Addendum (25-11607-30)

AN11 Updated Its Jumpers Orientations and Some Important Information about Optional RAID Features

The mainboard AN11 updated its jumper orientations and some information about the optional RAID features.

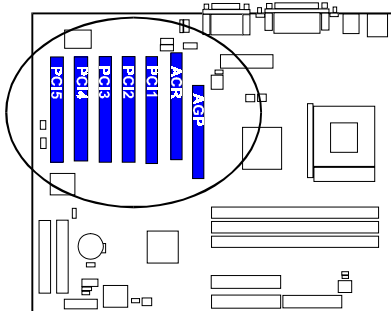
- 6). The dual power LED and power LED (3-pin) pin definition were updated as arrowheads pointed:

(If use dual power LED,
green; Pin2, yellow; Pin4;
otherwise, Pin2 is positive,
Pin4 is negative.) | (3). HDD LED |

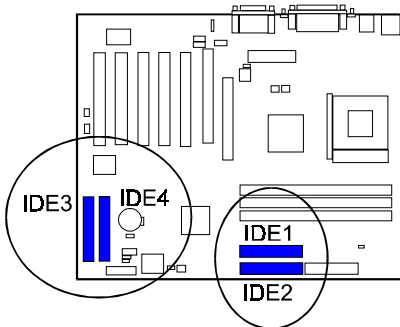
To use the optional RAID feature: (1). please set the jumper RAID_JP at RAID0/1; otherwise, it must stay at ATA100 (Default). (2). set up the RAID BIOS Utility while booting. (3). after operating system installed, set up the RAID software drivers. (if you use Windows 2000/XP, please copy the whole files in the subdirectory Promise/RAID into the floppy disks; then install the driver from the disks. If use ATA100 and Windows 2000/XP, please copy the whole files in the subdirectory Promise/ATA100 into the floppy disks; then install the driver from the disks.)
